GULMOHAR RESIDENCY

Details of Additions & Alterations

Flat No	509	Block no.	A
Flat Area	1360 sft	Type	Deluxe / Luxury
Buyer Name	Mr. A.Praveen Kumar Reddy		
Phone No.	9849582998, 9866803300	Email	praveen.ayinala@gmail.com

Description	Owners & Developers :	Date :	Promoted by
BLOCK-A-FLAT NO 109-PLUMBING PLAN(A1-TYPE)	Modi Reality Mallapur LLP	16.09.20	Jayapratha
	Project Name & Phase :		Soham Modi
	Gulmohar Residency		N.T.S
		Prepared By :	Modi Properties Pvt Ltd
		Approved By :	Phone: +91-40-66335551
		Scale :

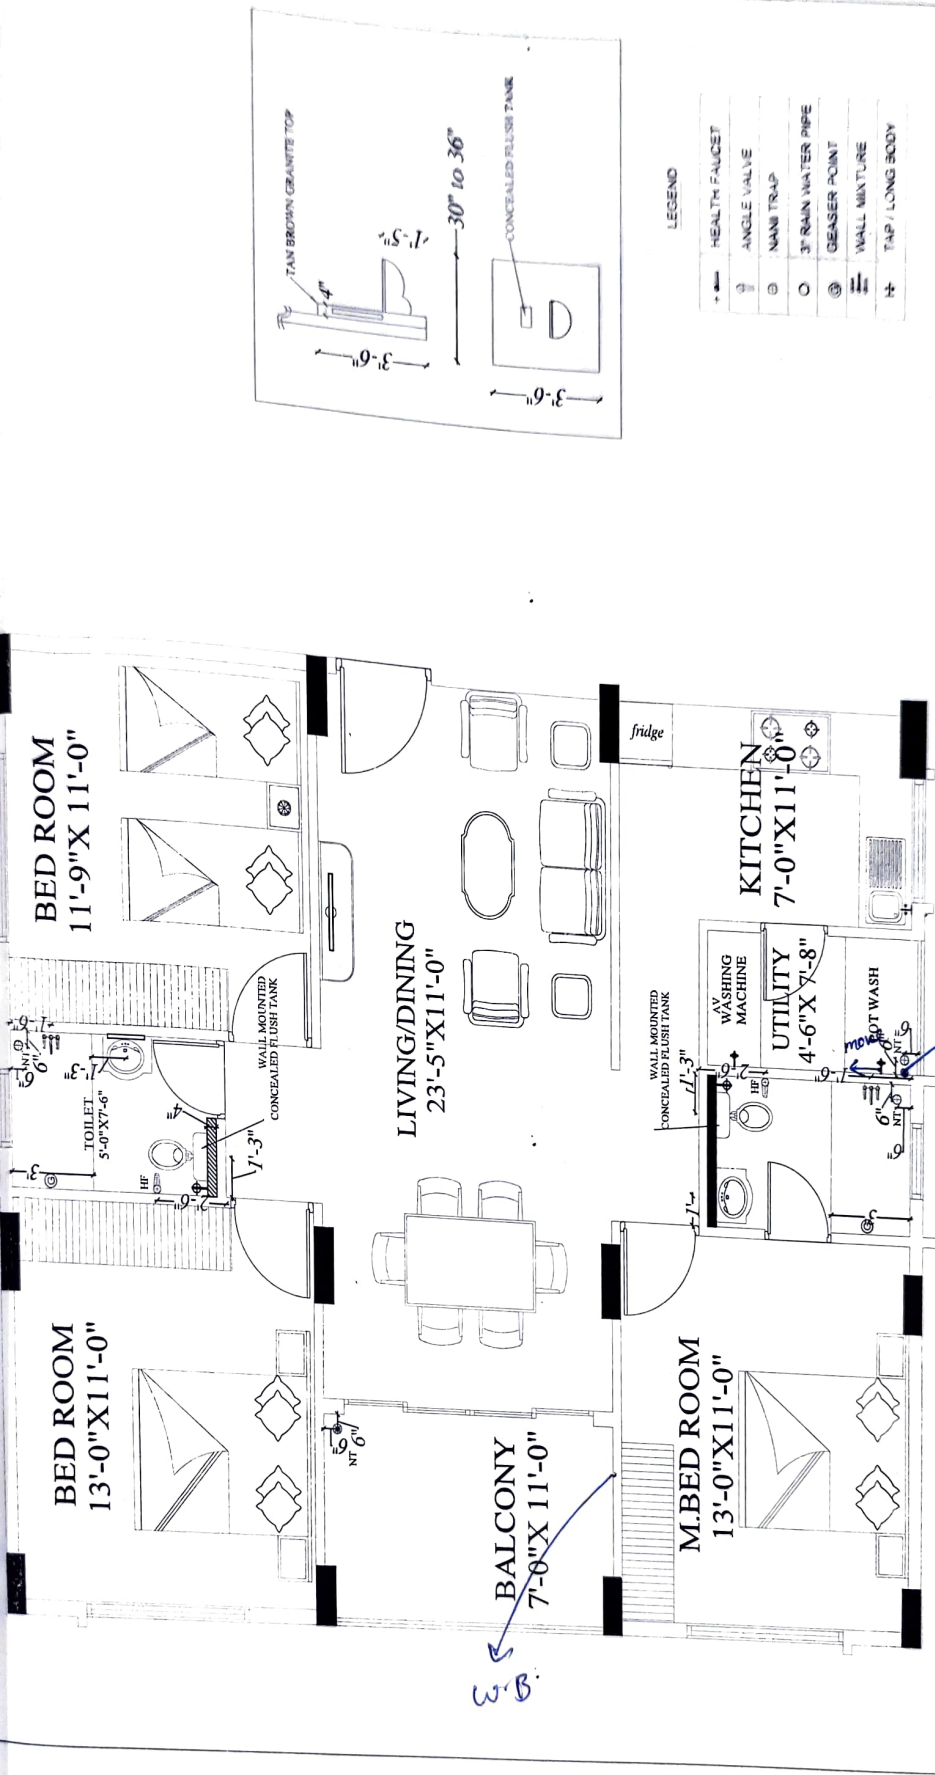
- ① Need ^{16amp} Socket on west wall in Bedroom
- ② Extra power point in kitchen.
- ③ Fan Points in living room to be moved 2' in.
- ④ Extra Socket in master bed room for AC point
- ⑤ Need 8 modal in master Bed room, living room.
- ⑥ Socket to be moved up 1'6" beside main door.

- ① M.T - Luna
- C.T - Ultra
